Addendum 2

Client: Creswell School District
Project: CHS Academic Building Improvements (Primary) Project
Date: March 5, 2026
To: Interested Bidder
Prepared by: Curt Wilson, AIA; Principal, Wilson Architecture

This Addendum modifies the Project Manual, Specifications, and Drawings as follows:

1 FLOOR PLAN - AREA A
A1.10 1/8" = 1'-0"

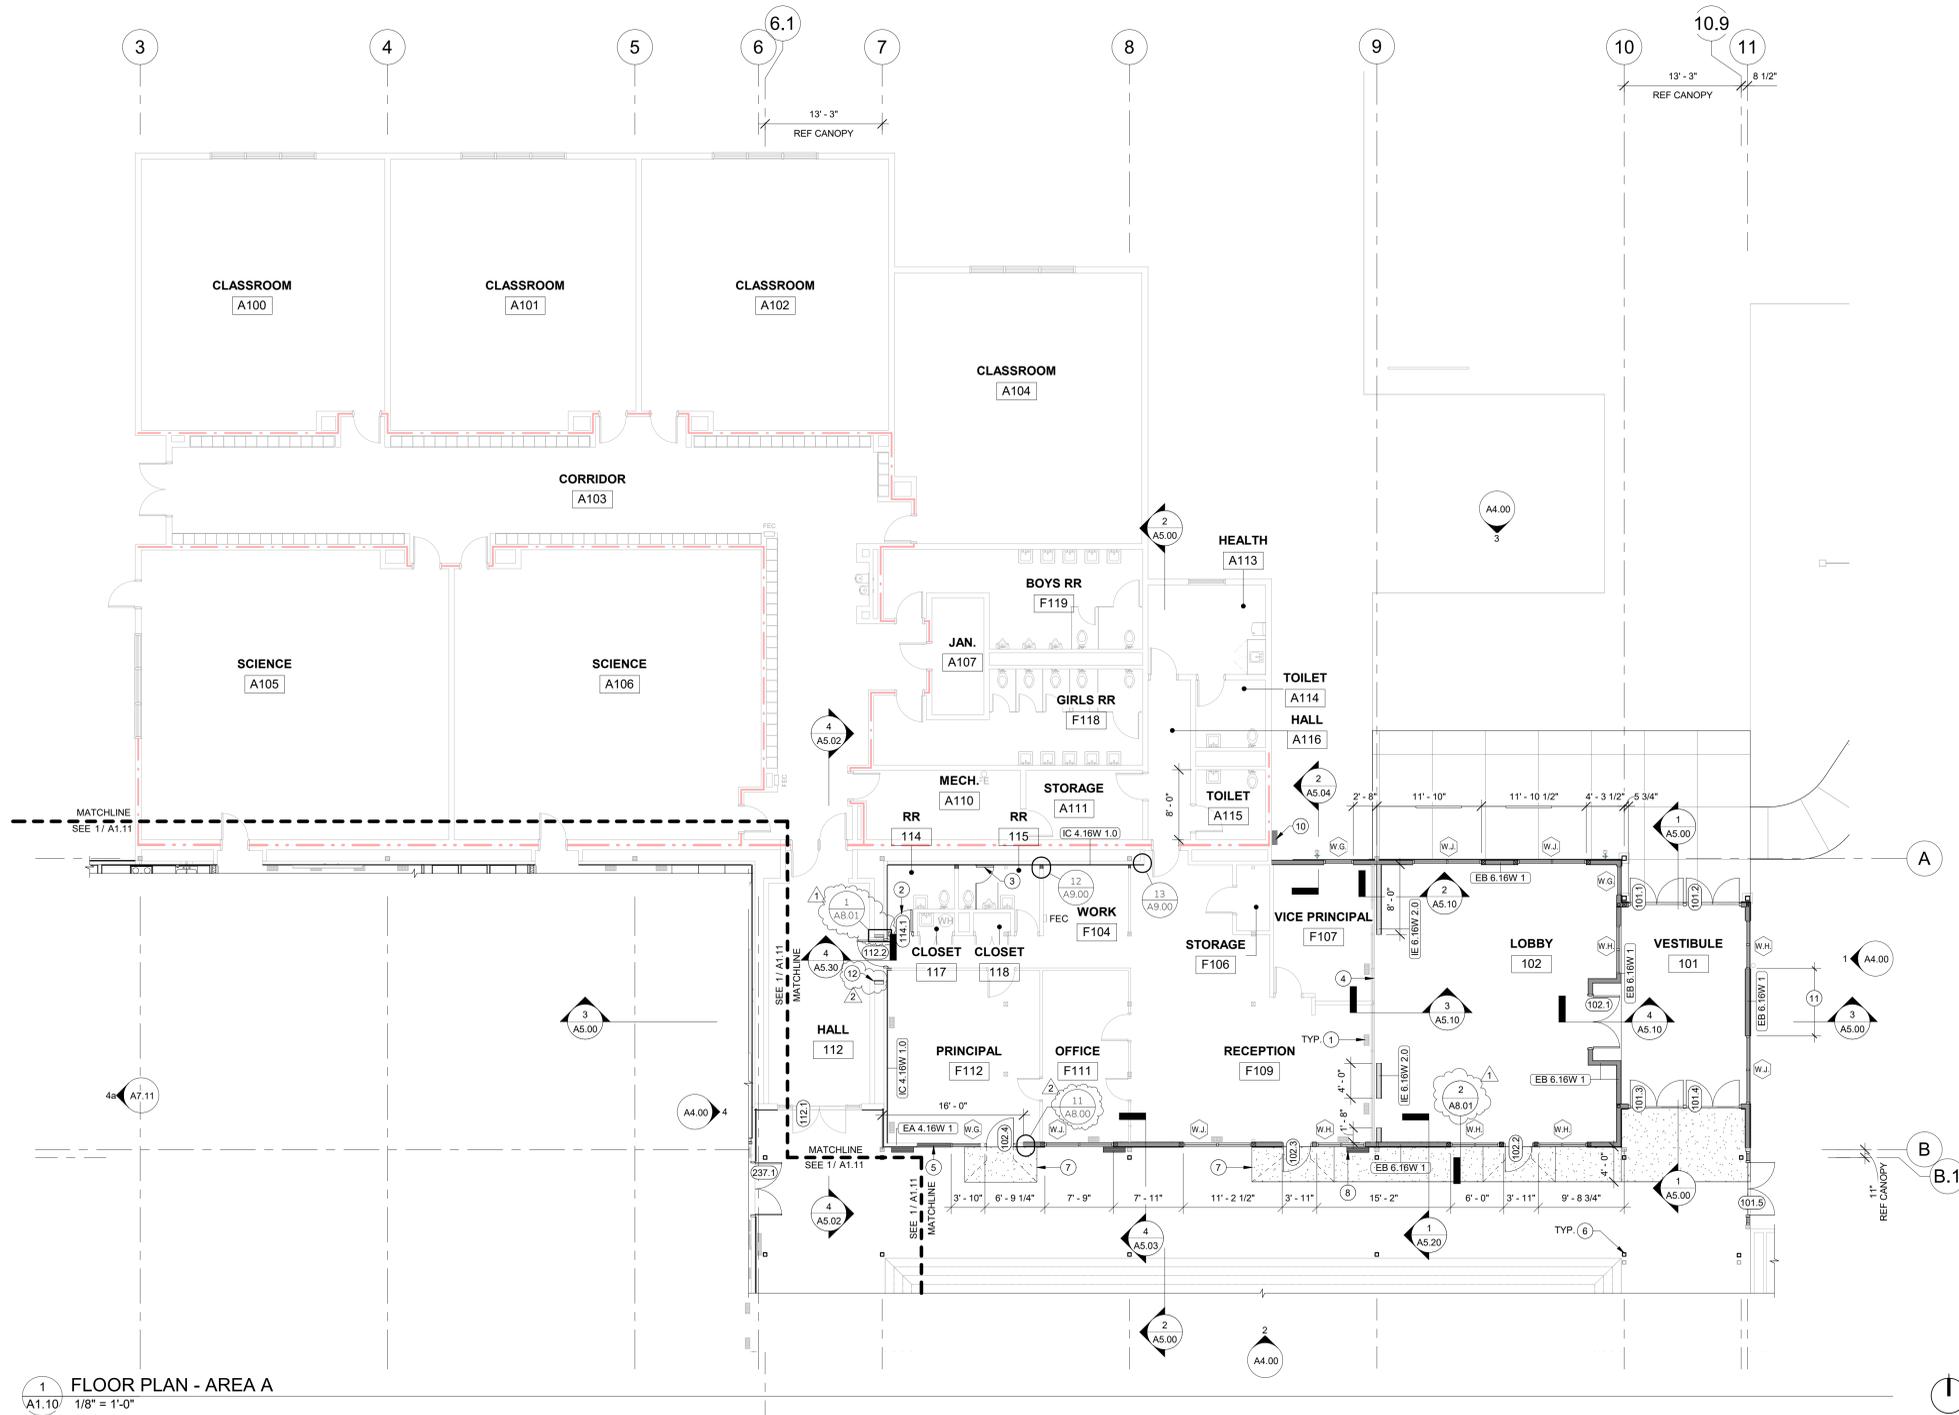
- Add wall repair notes and exterior detail reference.
- 3.7. Sheet A1.11
- a. Replace original sheet with attached version. A brief summary of the changes include:

1 FLOOR PLAN - AREA B
1/8" = 1'-0"

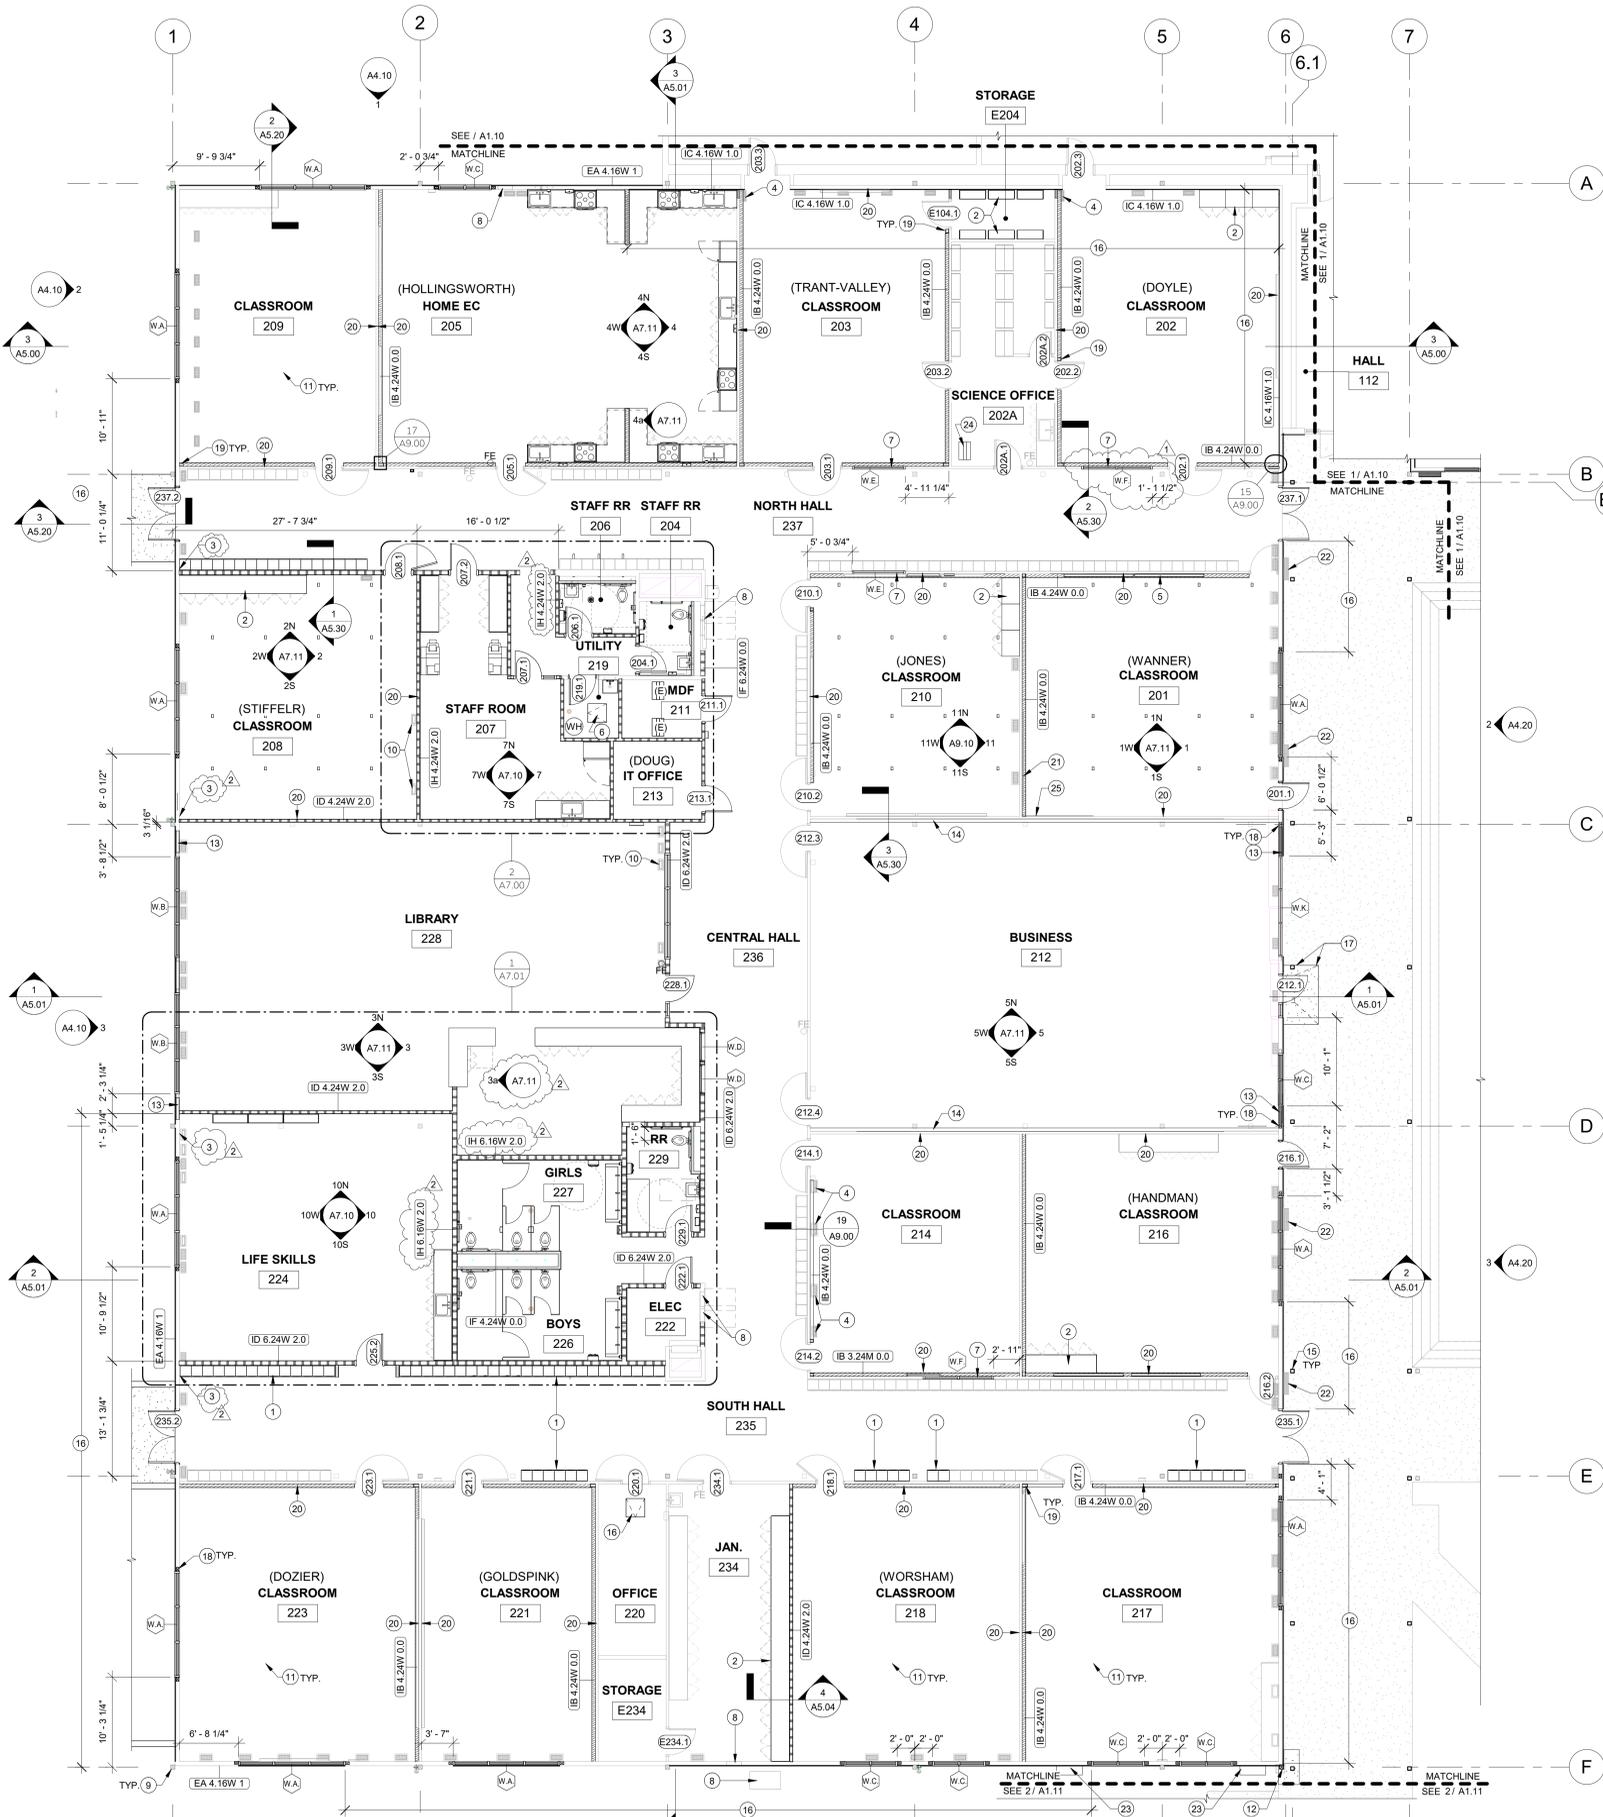
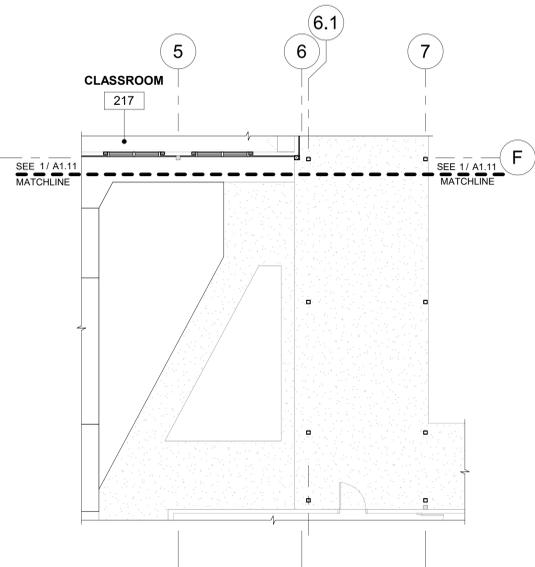
- Add wall repair notes and update wall tags for added wall assembly.
- 3.8. Sheet A5.04
- a. Replace original sheet with attached version. A brief summary of the changes include:

1 DEMO WALL SECTION - GL A
A5.04 3/4" = 1'-0"

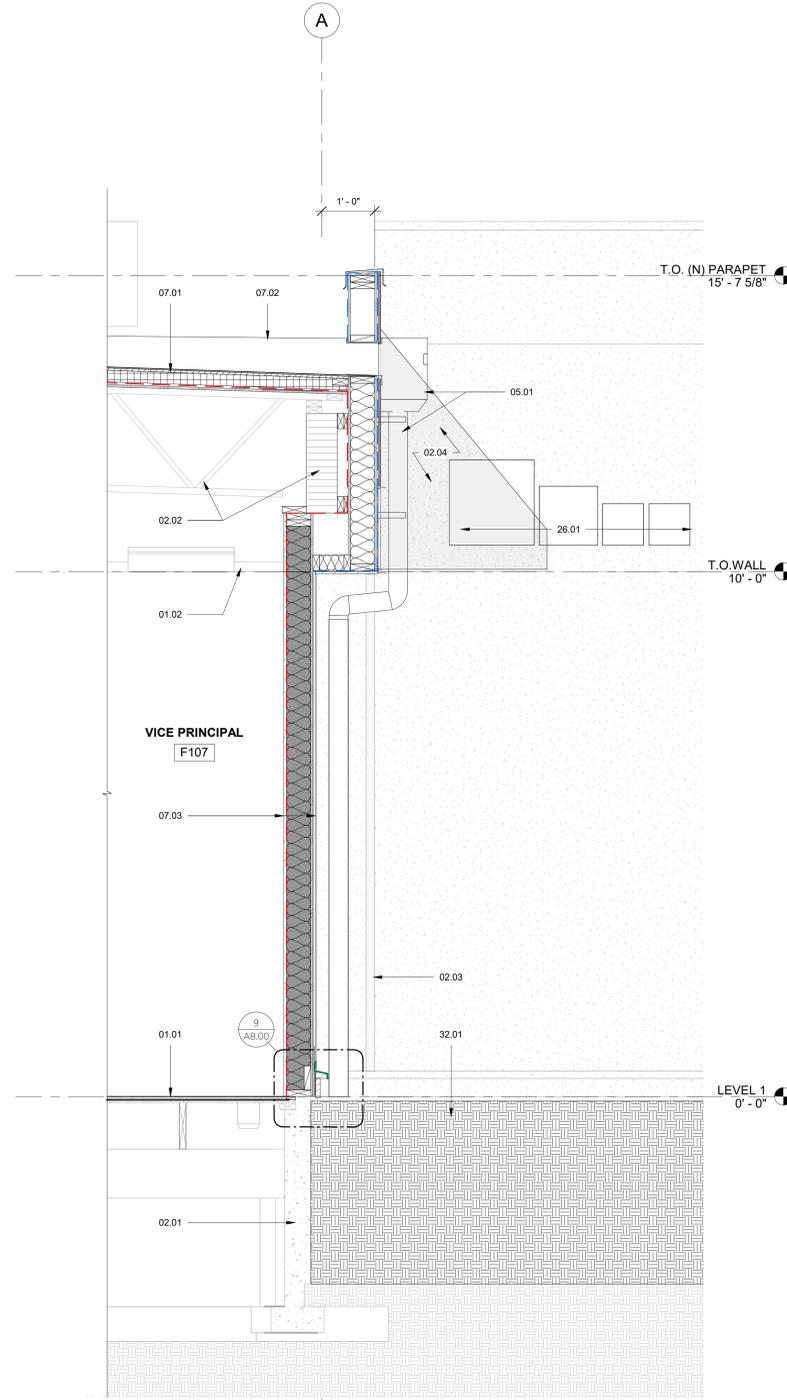
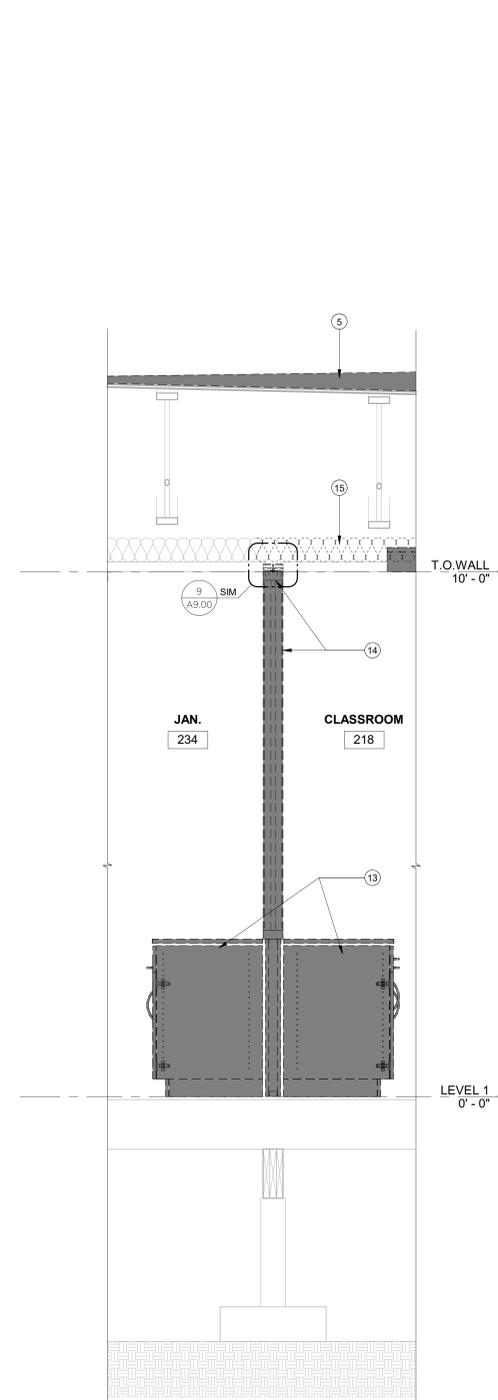
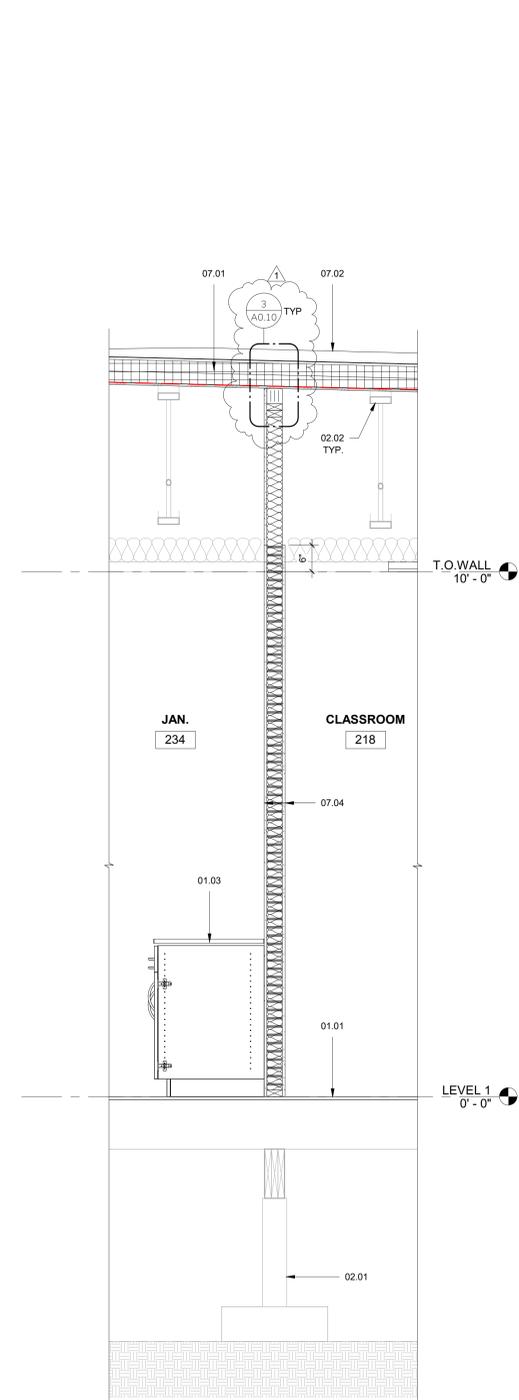
- Add top of wall detail reference.
- 3.9. Sheet A5.10
- a. Replace original sheet with attached version. A brief summary of the changes include:
 - Update wall location at Office Addition to match structural.
